# UNITED STATES PATENT AND TRADEMARK OFFICE

APPLICATION NO.	FILING DATE	FIRST NAMED INVENTOR	ATTORNEY DOCKET NO.	CONFIRMATION NO.
10/737,353	12/16/2003	Jennifer Johnson	JJ-645	6003
37282	7590	08/06/2004	EXAMINER	
HOWARD J. GREENWALD P.C. 349 W. COMMERCIAL STREET SUITE 2490 EAST ROCHESTER, NY 14445-2408			COLILLA, DANIEL JAMES	
			ART UNIT	PAPER NUMBER
			2854

<b>Office Action Summary</b>	<b>Application No.</b> 10/737,353	<b>Applicant(s)</b> JOHNSON ET AL.	
	<b>Examiner</b> Dan Colilla	<b>Art Unit</b> 2854

**DETAILED ACTION*****Drawings***

第 1 図

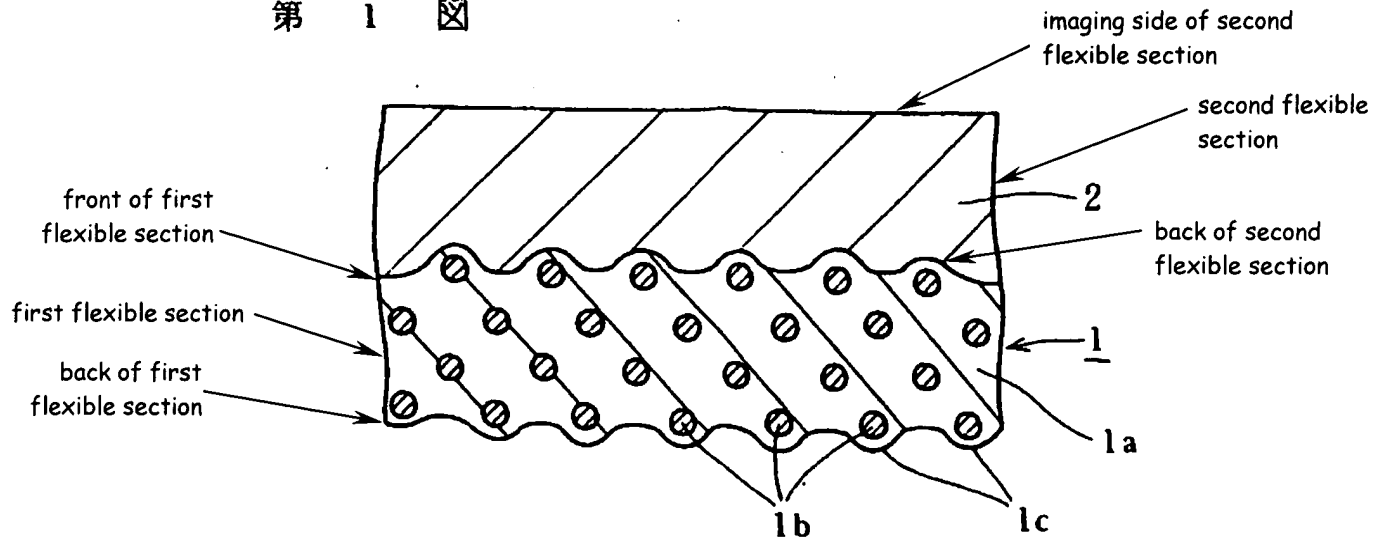
With respect to claim 1, Saito discloses the claimed thermal printing assembly except for the specific Sheffield smoothness and Knoop hardness values and the flexibility of the first section. Saito discloses a thermal printing assembly with a first section 1 having a first front side and a first back side as shown in Figure 1 of Saito. The first section 1 includes a multiplicity of first particles as mentioned in paragraph 1b. While Saito does not disclose specific Sheffield smoothness and Knoop hardness values, these values could have been determined by one of ordinary skill in the art through routine experimentation. It is known that harder materials can undesirably abrade less hard materials and less smooth materials can undesirably catch or create excessive friction when sliding against other materials. Wen et al. teaches a thermal assembly 40 that is flexible as shown in Figure 3 of Wen et al. It would have been obvious to combine the teaching of Wen et al. with the thermal assembly disclosed by Saito for the advantage of conveniently storing the thermal assembly by wrapping it on a spool (US 5,865,548).

With respect to claim 3, Saito et al. teaches an imaging side and a back side of the material 2 such that the back side of material 2 is congruent with the front side of section 1 as shown below in the Figure taken from Saito et al.:

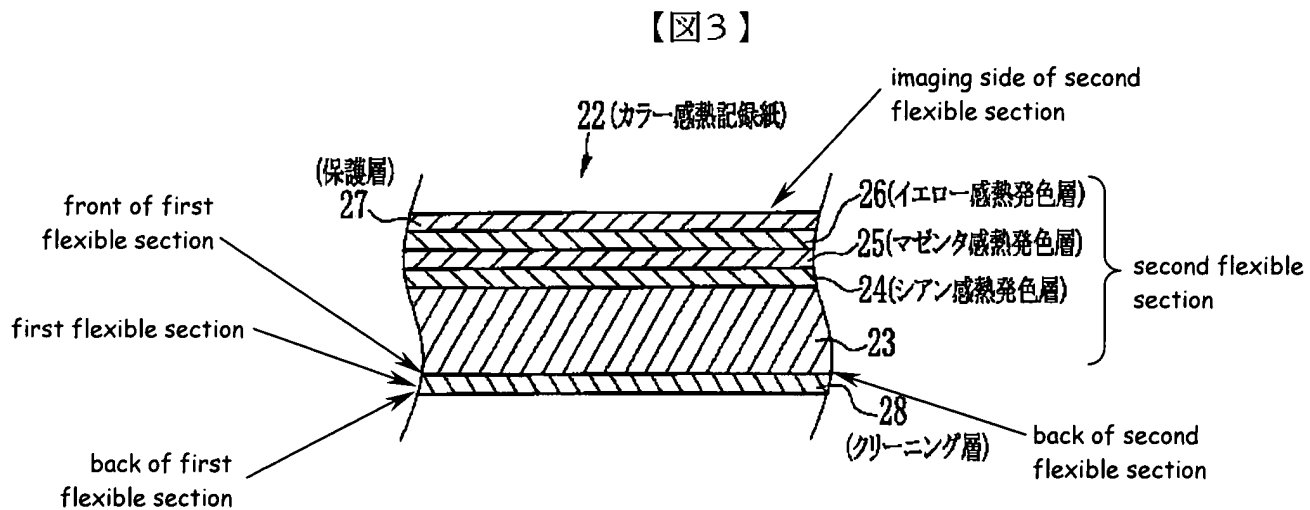
With respect to claim 1, Miyazaki et al. discloses the claimed thermal printing assembly except for the specific Sheffield smoothness and Knoop hardness values. Miyazaki et al. discloses a thermal printing assembly including a first flexible section 28 as shown in Figure 3 of Miyazaki et al. The first section is flexible enough so that it can be fed out of the paper cassette 13 as shown in Figure 1 of Miyazaki et al. The first flexible section 28 includes particles as disclosed in paragraph [0039] of the machine translation of Miyazaki et al. While Miyazaki et al. does not disclose specific Sheffield smoothness and Knoop hardness values, these values could have been determined by one of ordinary skill in the art through routine experimentation. It is known that harder

With respect to claim 4, the thermally sensitive media is a direct thermal sensitive substrate with a first imaging side and a second back side congruent with a first front side of the first flexible section 28 as shown below in the image taken from Figure 3 of Miyazaki et al.:
